Date: **September 27, 1993**

Subject: **NEW EXTERNAL POWER JACK**

Model: **BVM-8021**

Figure 1

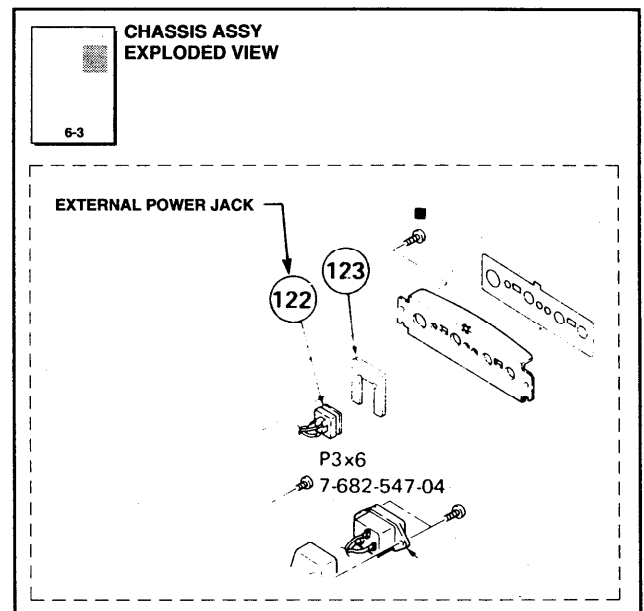
If a battery other than an BP-90 or BP-90A is used, the positive side terminal of the external power jack may contact the chassis, thereby causing excessive current to flow from the battery.

To prevent this from occurring, replace the external power jack with the high-shock resistant one and add insulation tape to the bottom of the jack to isolate it from the FB block.
